WESTERN NUCLEAR, INC.

August 29, 2008

Re: Western Nuclear Inc., Split Rock Uranium Mill Tailings Facility, Source Materials License SUA-56, Proposed Amendments to License Condition 74.

Figure 1 - Sulfate in POE Wells

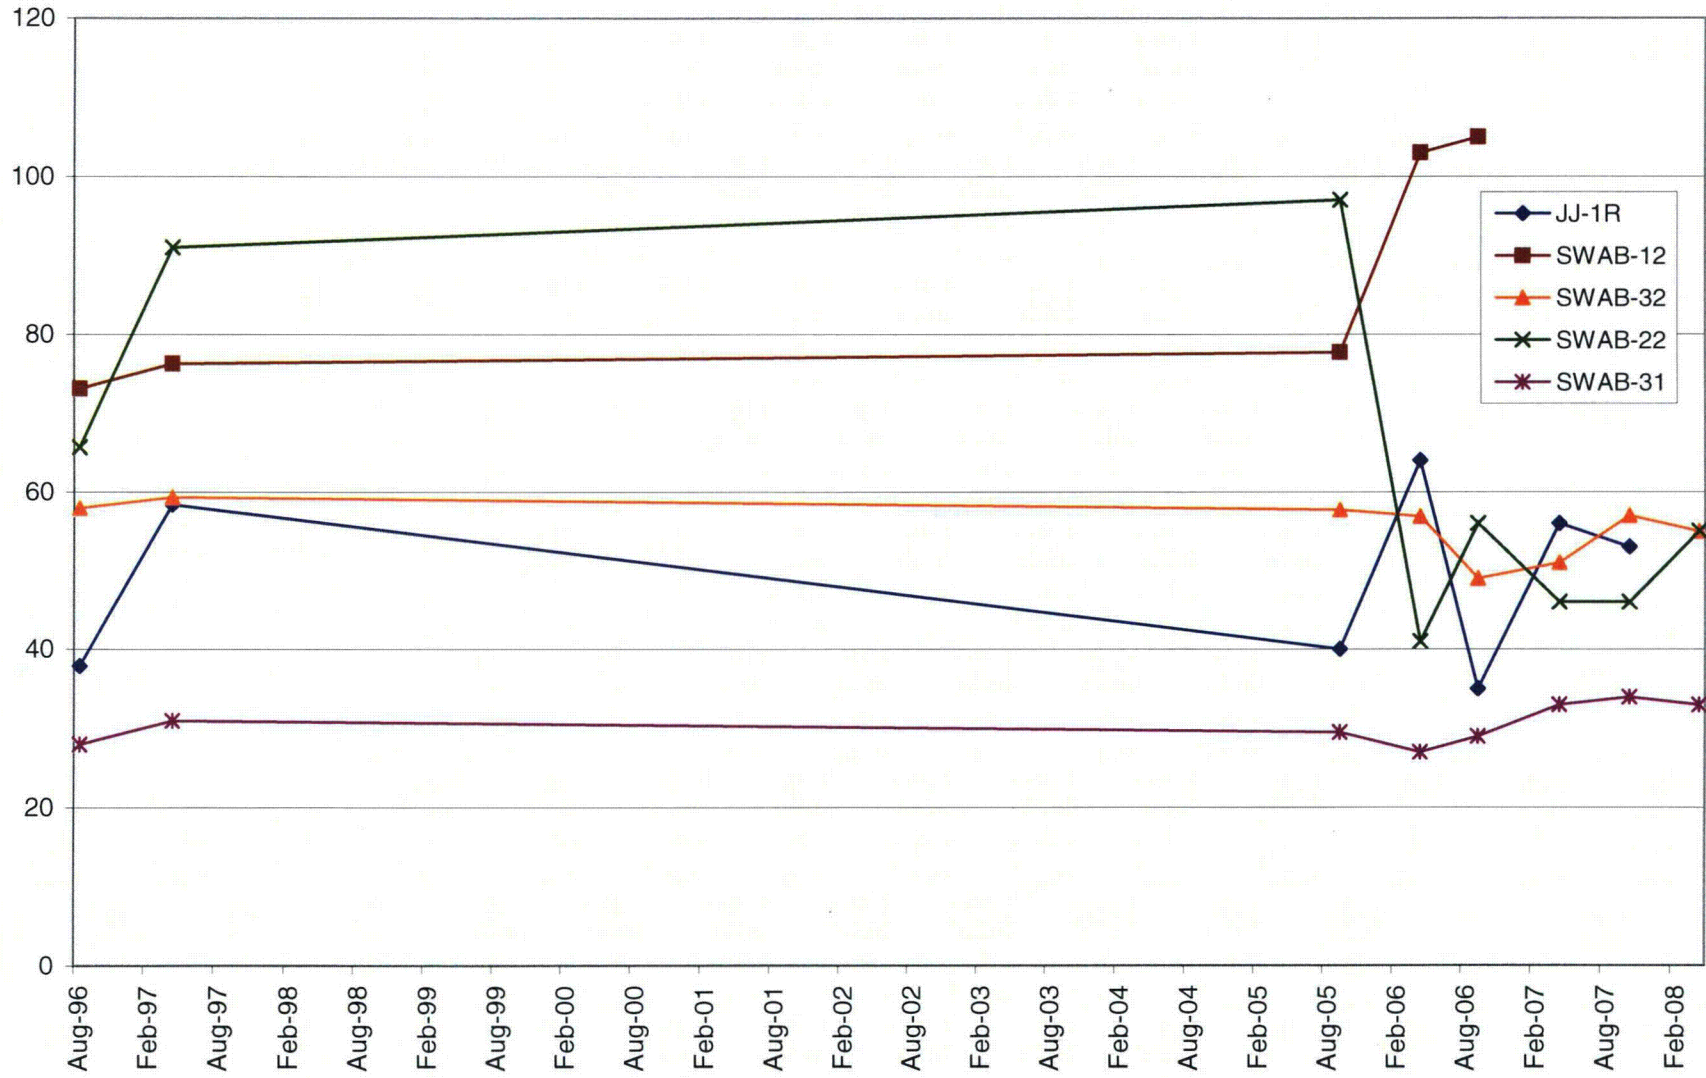
It is also proposed that the trigger limits be changed to be consistent with background concentrations. For example, the existing trigger limit for uranium is set at the MCL for uranium at 0.03 mg/l (except for well SWAB-32 which has been shown to have naturally occurring uranium at concentrations greater than the rest of the site). Site wide background values for uranium in the Split Rock Aquifer is 0.13 mg/l as documented in Table 3 of the 2006 NRC Environmental Assessment. However, it is recognized that the concentrations in some of the POE wells are less than the statistically derived background values and setting the trigger levels at the statistical background values might not be appropriate. Therefore it is proposed that the trigger levels be based on historic values measured in each of the POE wells.

Figures 1 and 2 show the historic uranium and sulfate values for the POE wells. Although there are limited data, a visual upper limit can be estimated that would be an appropriate trigger levels to indicate if conditions are different and further evaluation would be warranted. These visual limits for each well are proposed for trigger levels in Table 2. It is possible, when additional data are available, that a statistically based intra-well trigger value could be calculated for each well. In the interim, the proposed trigger levels will provide the necessary early indication of changing conditions.

Comply with the following ground water trigger levels at the point of exposure wells which are defined as wells JJ-1R, SWAB-12, SWAB-22, SWAB 31 and SWAB-32:

Well	Sulfate	Uranium
JJ-1R	100 mg/l	0.03 mg/l
SWAB 12	150 mg/l	0.1 mg/l
SWAB 22	150 mg/l	0.05 mg/l
SWAB 31	50 mg/l	0.05 mg/l
SWAB 32	100 mg/l	0.3 mg/l

Figure 3 - Surface Water Sulfate

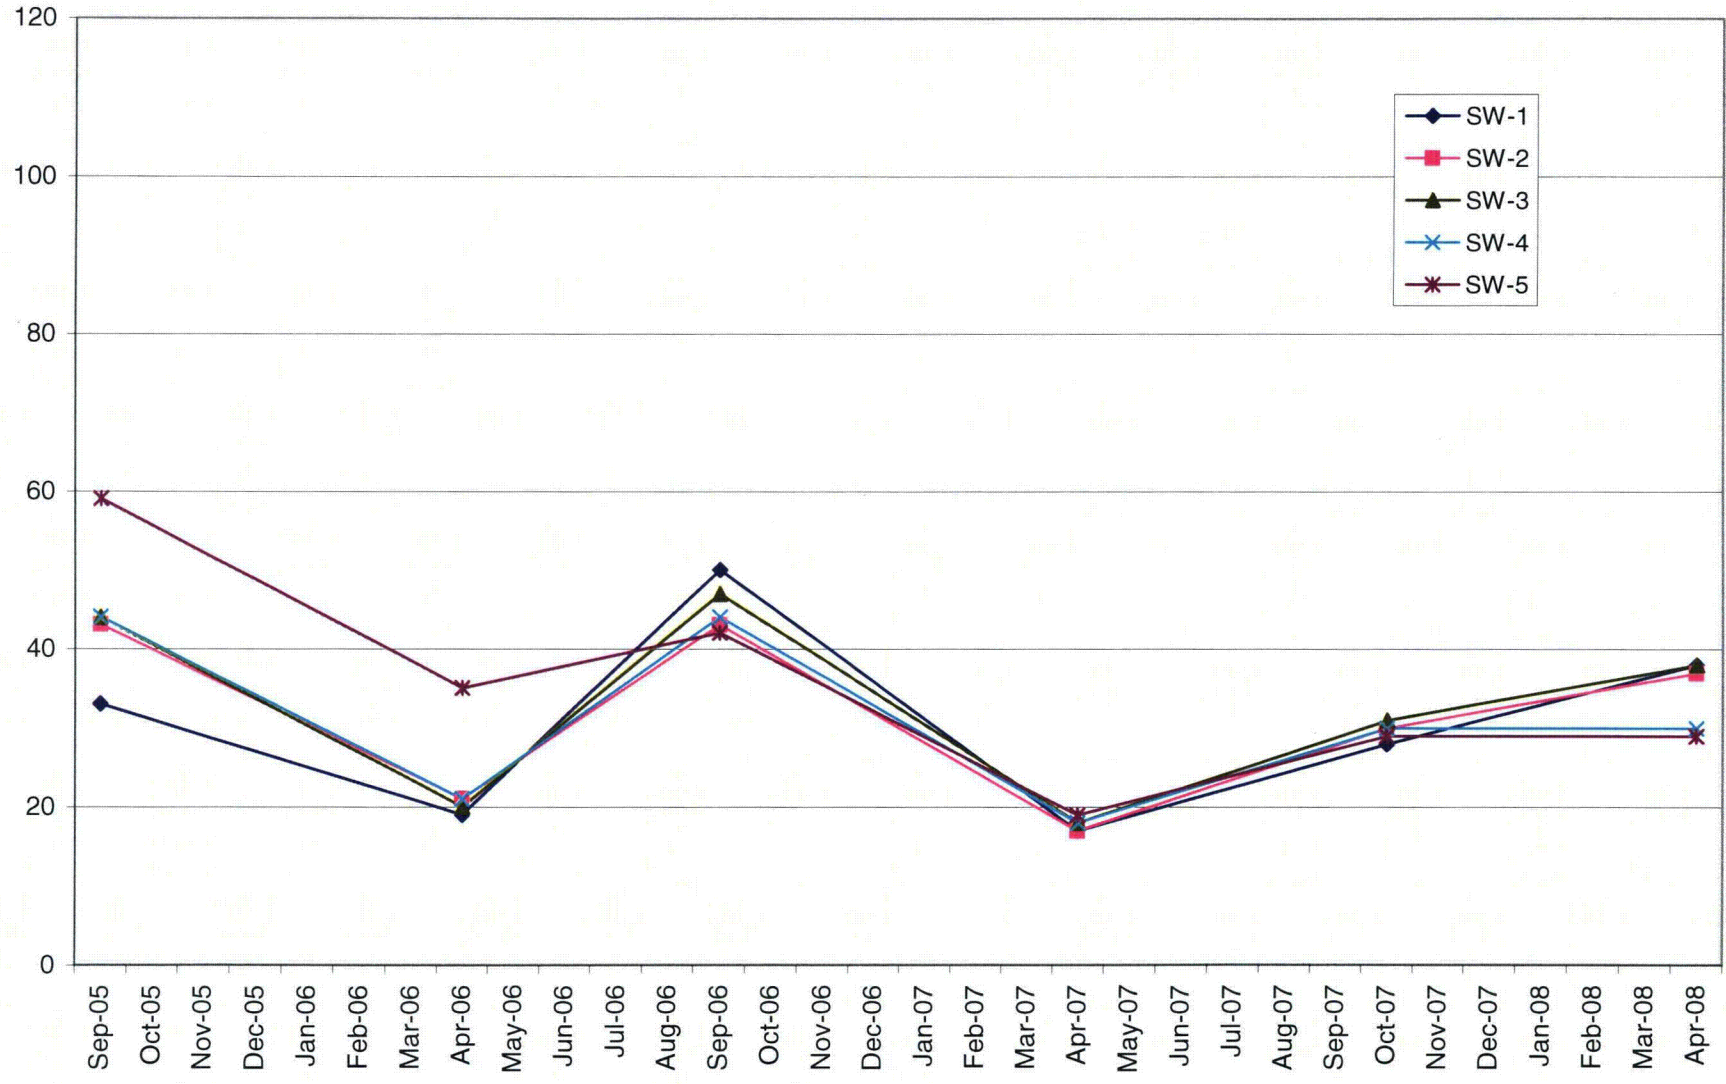
As with the groundwater POE locations, sulfate and uranium are the best indicators of seepage and these parameters are monitored semi-annually. The trigger levels were also determined in the same manner as they were for the groundwater POE wells. Figures 3 and 4 show the historic uranium and sulfate values

for the surface water sampling locations. It is proposed that the uranium trigger level remain at 0.03 mg/l and the sulfate trigger level be set at 100 mg/l. As with the groundwater trigger levels, it might be possible to change the trigger levels in the future to a more statistically based value once more data have been collected.

Comply with the following surface water trigger levels at surface water monitoring locations SW-2, and SW-5: natural uranium = 0.03 mg/l and sulfate = 100 mg/l.
